Intel[®] Pentium[®] III Processor Specification Update

Release Date: August 2007

Document Number: 244453-058

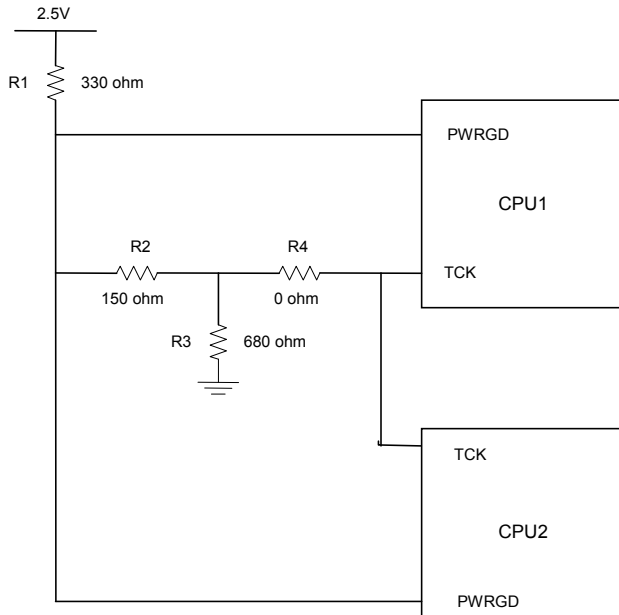
Problem: The internal control register bit responsible for operation of the Thermtrip circuit functionality may power up in a non-initialized state. As a result, THERMTRIP# may be incorrectly asserted during de-assertion of RESET# at nominal operating temperatures. When THERMTRIP# is asserted as a result of this erratum, the processor may shut down internally and stop execution but in few cases continue to execute.

Implication: This issue can lead to intermittent system power-on boot failures. The occurrence and repeatability of failures is system dependent, however all systems and processors are susceptible to failure. In addition, the processor may fail to stop execution during the event of a valid THERMTRIP# assertion resulting in the potential for permanent processor damage.

Workaround: To prevent the risk of power-on boot failures or catastrophic thermal failures, a platform workaround is required. The system must provide a rising edge on the TCK signal during the power-on sequence that meets all of the following requirements:

- Rising edge occurs after Vcc_core is valid and stable
- Rising edge occurs before or at the de-assertion of RESET#
- Rising edge occurs after all Vref input signals are at valid voltage levels
- TCK input meets the Vih min and max spec as mentioned in EMTS
